APPLICATION NO.	FILING DATE	FIRST NAMED INVENTOR	ATTORNEY DOCKET NO.	CONFIRMATION NO.
10/705,862	11/13/2003	Kiyoji Aoshima	2003_1633A	6306

Office Action Summary	Application No. 10/705,862	Applicant(s) AOSHIMA ET AL.	
	Examiner Debra Wolfe	Art Unit 3725

DETAILED ACTION

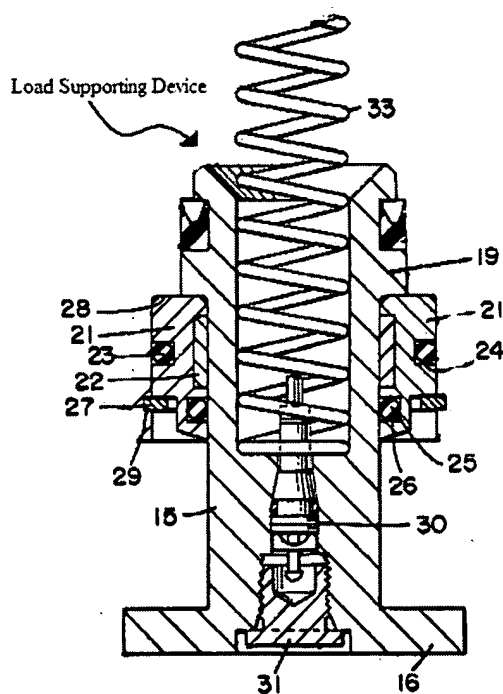
With regards to claims 14 and 15, Applicant's admitted prior art discloses a press machine having a die cushion (59), which receives a load supplied through a plurality of cushion pins (57) by a die cushion pad (69), comprising a plurality of load supporting devices (hydraulic cylinders 58) disposed on the die cushion pad (69) and in abutment with the cushion pins (57) [See FIG 15 of Applicant's drawings]. Applicant's admitted prior art fails to disclose a load supporting device having an elastic member and wherein the elastic member of each of the load supporting devices produces a pushing force in an axial direction of the associated cushion pin. However, Wallis discloses a load supporting device [See FIG below] having an elastic member

(spring 33) that is provided coaxially with respect to an associated cushion pin (cylinder 11) and produces a pushing force in an axial direction of the associated cushion pin (cylinder 11) for the purpose of eliminating the deleterious effects of oil or other contaminants from the exterior of the press or die. Therefore, it would have been obvious to one of ordinary skill in the art at the time the invention was made to modify the load supporting devices of Applicant's admitted prior art with the load supporting devices of Wallis in order to provide a clean and more efficient environment around the press.
